TYPICAL FLOOR PLAN (2 TO 7)

ARCHITECT						TITLE					
DRAWN						WORKING DRAWING — TYPICAL FLOOR (2 TO 7) — REVISED AS PER SITE SETBACK (SHOWING WITH STRUCTURE)					
DATE						PRINT STATUS:					
SCALE						☐ SCHEMATIC					
CHECKED						☒ APPROVED FOR CONSTRUCTION					
THIS DRAWING IS THE PROPERTY OF M/S. KECHA ARCHITECTURE & INTERIOR ARCHITECTURE, AND ITS USE IN ANY MANNER, OTHER THAN FOR WHAT IT HAS BEEN ISSUED FOR, IS PROHIBITED.						DRAWING NO.					
						A 14_01_03					
						11

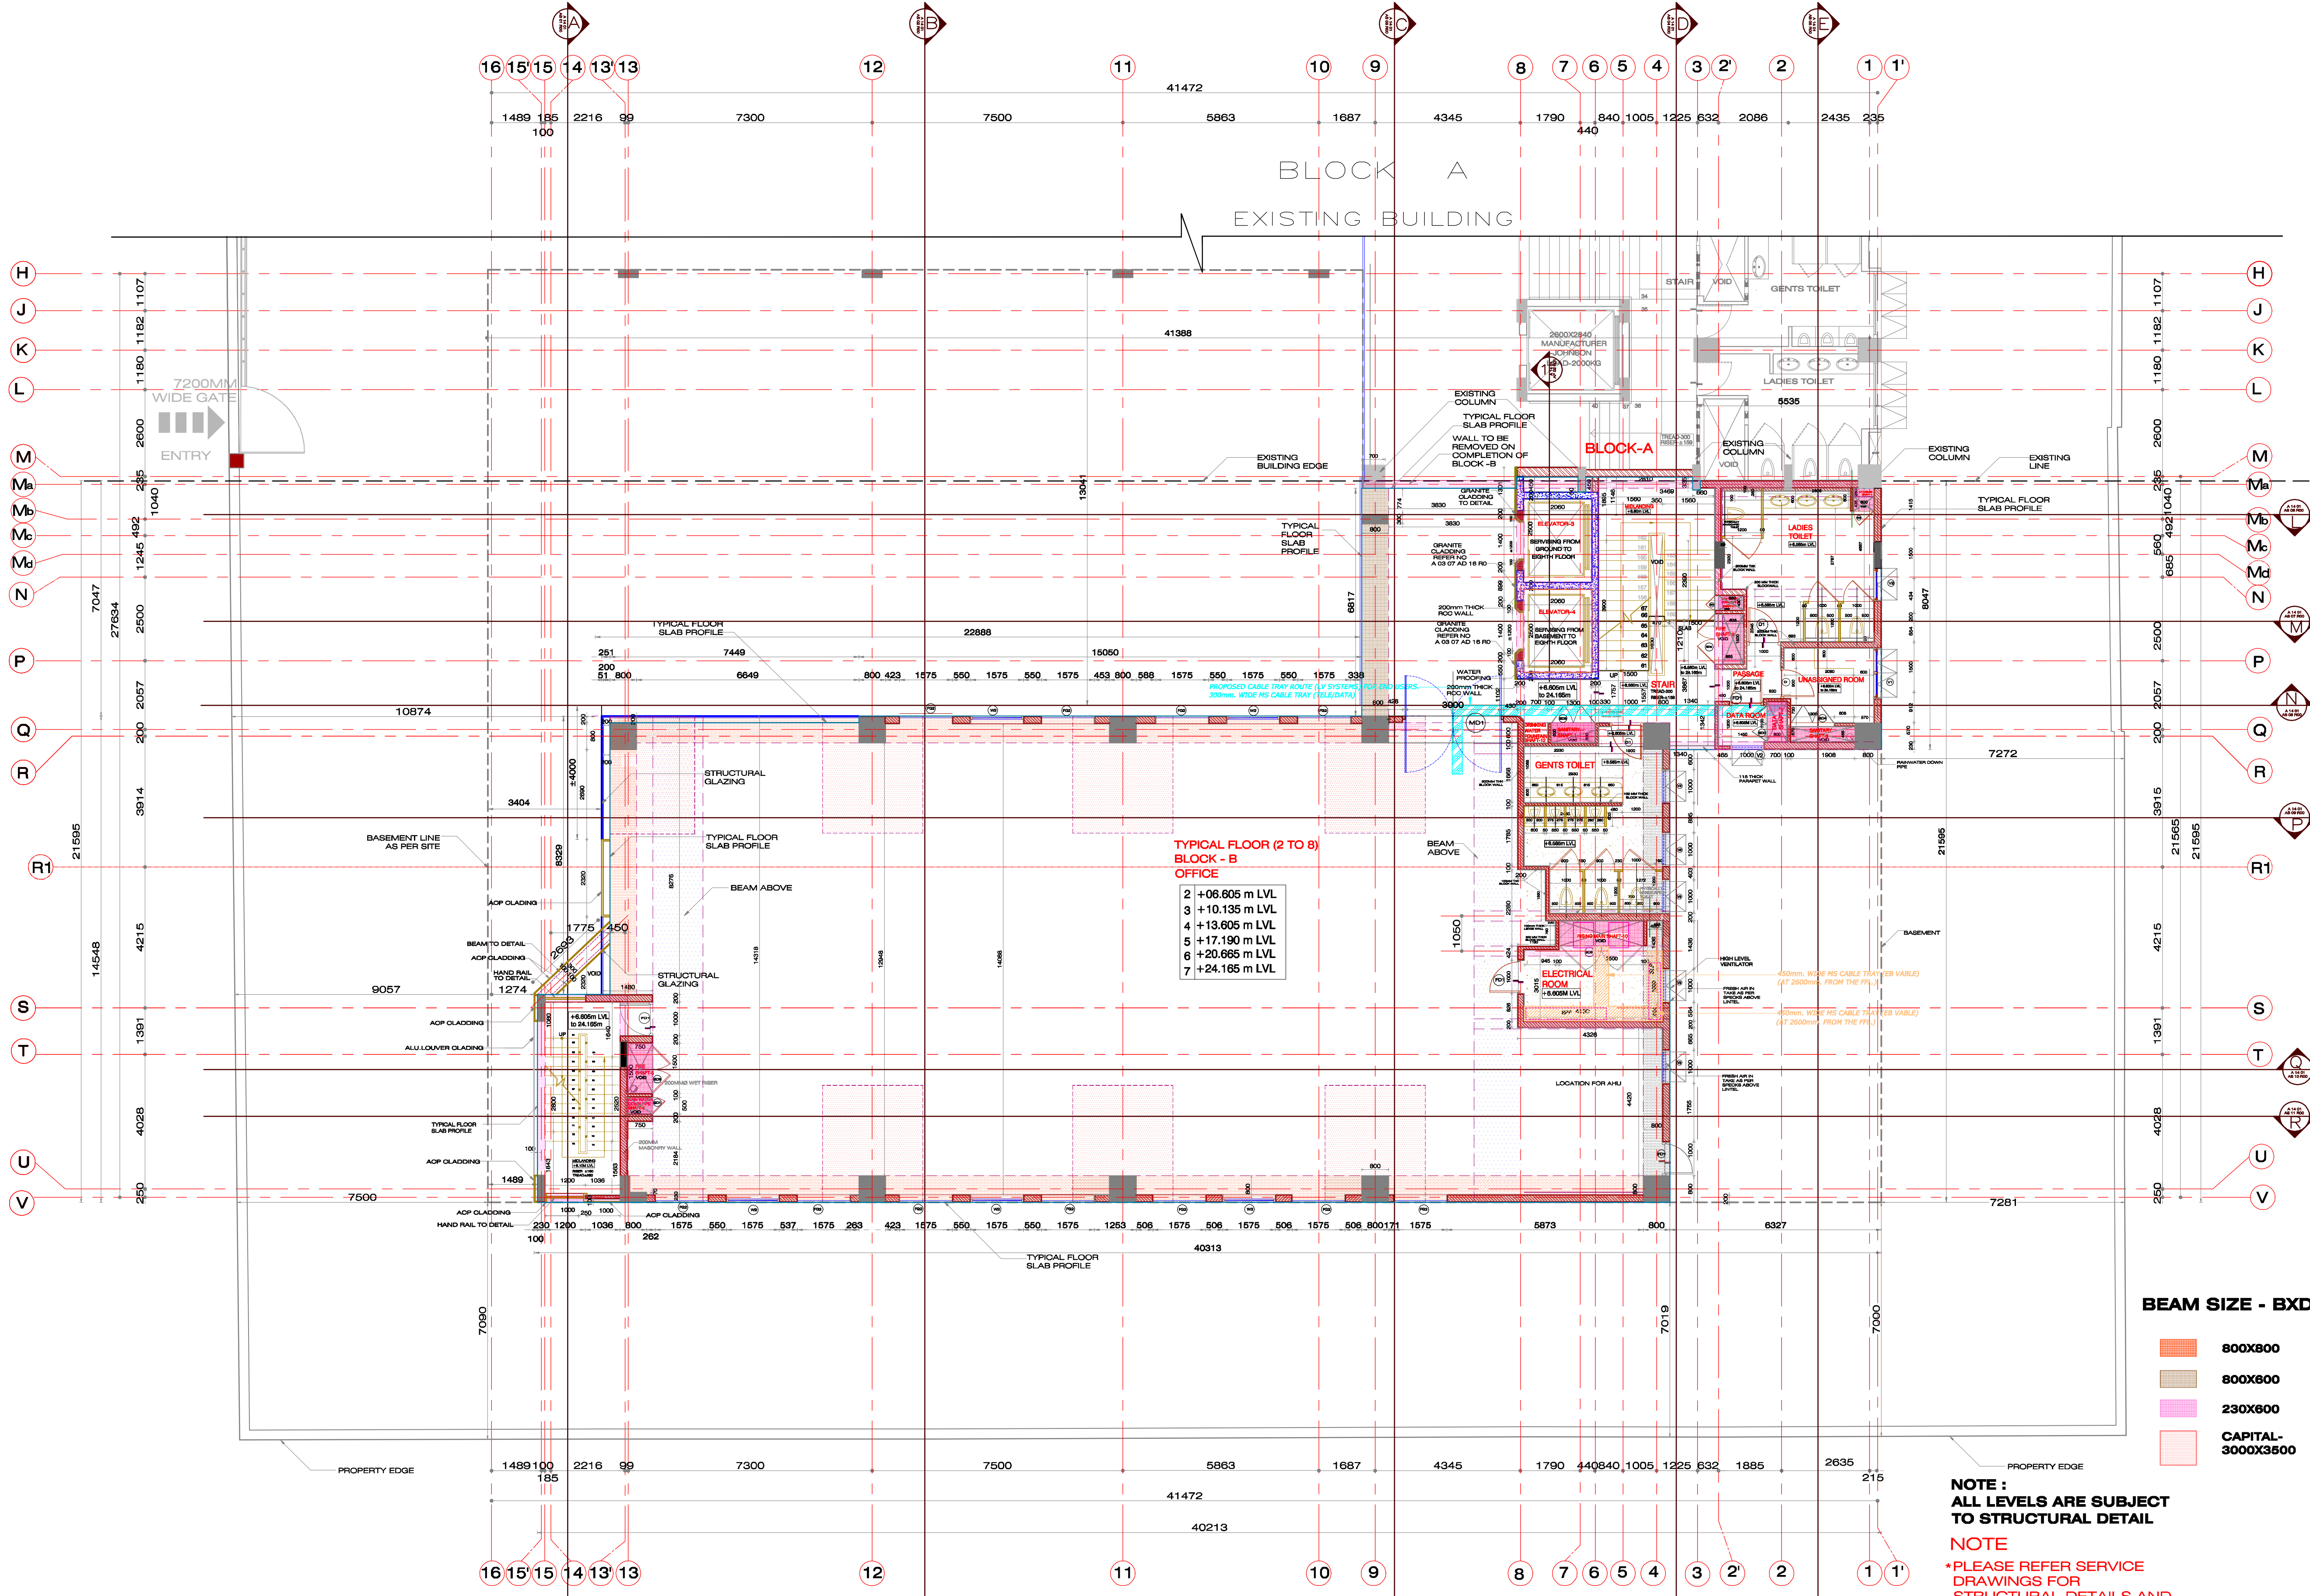
SL.NO	DATE	NAME	REVISION	SL.NO	DATE	NAME	REVISION	SL.NO	DATE	NAME	REVISION
01	30.12.2014	NISHA	A NEW COLUMN WAS ADDED IN THE ELECTRICAL ROOM. 300MM SQUARE COLUMN TO BE ADDED IN ELECTRICAL ROOM. 300MM SQUARE COLUMN TO BE ADDED IN ELECTRICAL ROOM.	06	21.03.2015	NISHA	ALL WALLS 200 RPTV CHANGE	10	21.11.2015	NISHA	LOCATION FOR AHU ROOM AREA CHANGE
02	05.02.2015	NISHA	MANUFACTURING CORRECTION	07	03.04.2015	NISHA	LADIES TOILET/PANTRY STORE DOOR CHANGE, AHU ROOM CHANGE,	11	05.01.2016	NISHA	MAIN STAIRCASE AREA LEVELS CHANGED
03	25.01.2015	NISHA	ELECTRICAL ROOM ADDED, ELECTRICAL ROOM CHANGED INTO PANTRY/STORE	08	22.05.2015	NISHA	LADIES TOILET/GENTS TOILET PARTITION WALL CHANGE				
04	02.03.2015	NISHA	THE DEPTH OF THE SHIRT CHANGED FROM 800MM TO 700MM IN ELECTRICAL ROOM	09	30.06.2015	SHANMATHI	LADIES TOILET VENTILATOR CHANGED ELECTRICAL ROOM DOOR SIZE CHANGED				
CLIENT											
PRAMOD MADHAVAN						SINTRON ELECTRONICS PVT LTD — PHASE 3
